PFEIFFER FAMILY ESTATES SUBDIVISION

APPLICATION NUMBER 5 DATE December 18, 2014

APPLICANT Pfeiffer Family Estates Subdivision

REQUEST Subdivision

DETAIL SITE PLAN

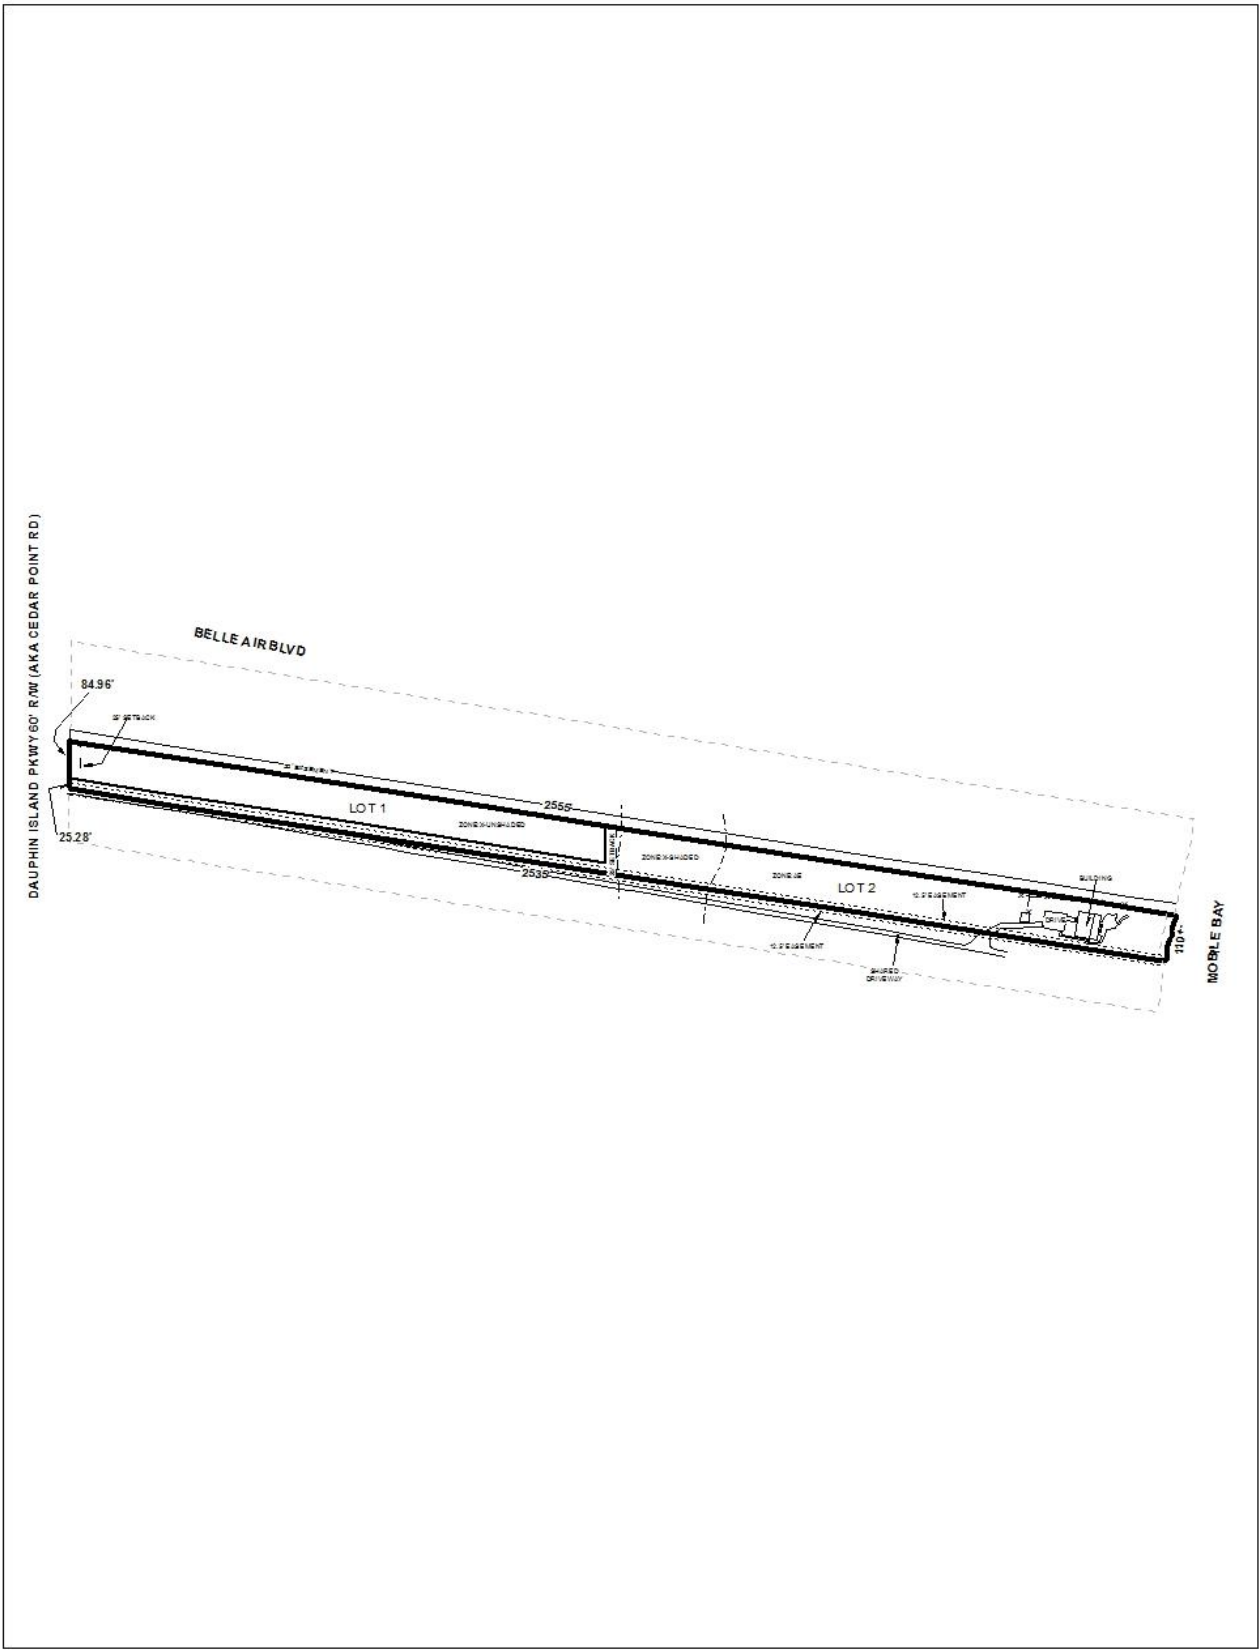
As originally presented, only two of the proposed lots would have direct street frontage. The third lot, on the East end toward Mobile Bay, would have been land-locked and accessed by a 25' easement for ingress and egress. In similar instances, easements have been allowed as substitutes for direct street frontage if the easement pre-dated inclusion of the subject site into the Planning Jurisdiction. However, in this instance, the easement was proposed as part of the subdivision. The applicant was made aware of the disallowance of the proposed easement as proper access and has agreed to this application being considered as a two-lot subdivision instead. As such, each lot would then have the required 25' minimum street frontage. Due to the narrowness of the property, the applicant does not deem it feasible to provide a "finger" for the third proposed lot.

The plat indicates a 25' building setback line for both lots and this should also be shown on the Final Plat. Both lots meet the minimum size requirements of the Subdivision Regulations and are labeled with their sizes in acres on the preliminary plat. The plat should be revised to label each lot with its size in both square feet and acres, or a table should be furnished on the Final Plat providing the same information.

Lot 2 would be a flag lot which is generally discouraged by Section V.D.1. of the Subdivision Regulations. However, they are permitted only in instances of family subdivisions or in those locations where varied and irregularly-shaped lot designs are common and the informality of design is consistent with other lots in the vicinity. Both of those qualifications exist. This is a family subdivision and there have been other flag lot subdivisions allowed by the Commission within the vicinity and this particular subdivision would be similar. Both lots would exceed the maximum depth-to-width ratio of 3.5 at the building setback line allowed by Section V.D.3 of the Subdivision Regulations. However, this is typical of other long-existing lots within the vicinity and typical of other Commission-approved subdivisions within the vicinity. Therefore, waivers of Sections V.D.1. and V.D.3. of the Subdivision Regulations would be in order. A note should be required on the Final Plat stating that no further resubdivision of either lot is allowed until additional public street frontage is provided.

- 1) the Final Plat retain the revised two-lot configuration;
- 2) placement of a note on the Final Plat stating that each lot is limited to one curb cut to Dauphin Island Parkway, with the size, location and design to be approved by County Engineering and conform to AASHTO standards;

- 3) retention of the 25' minimum building setback line on both lots;
- 4) revision of the plat to label each lot with its size in both square feet and acres, or the furnishing of a table on the Final Plat providing the same information;

- 5) placement of a note on the Final Plat stating that no further resubdivision of either lot is allowed until additional public street frontage is provided;
